News Channel Update

то: Mercedes-Benz Dealer Principals, General Managers, Sales Managers, Service Managers, Parts Managers	FROM: Joe Haller, Senior Manager – Warranty, Gregory Gunther - Senior Manager, Vehicle Compliance and Analysis, Engineering Services
RE: Emission Extended Warranty – Engine Thermostat (incl. software update) MY20-23, Various Models and Platforms (167, 190, 205, 213, 217, 222, 223, 232, 253, 290, 463)	DATE: December 01, 2023

IMPORTANT EMISSION EXTENDED WARRANTY INFORMATION

Figure 1

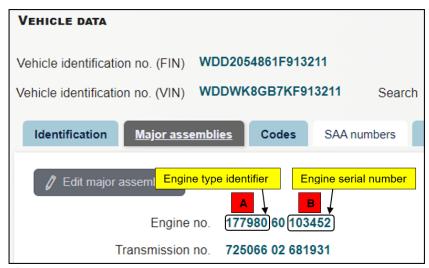
- a. Look up the engine number in VeDoc
- b. Identify engine type, first 6 digits (A,Figure 1)
- c. Identify engine serial number, last 6 digits (B, Figure 1)
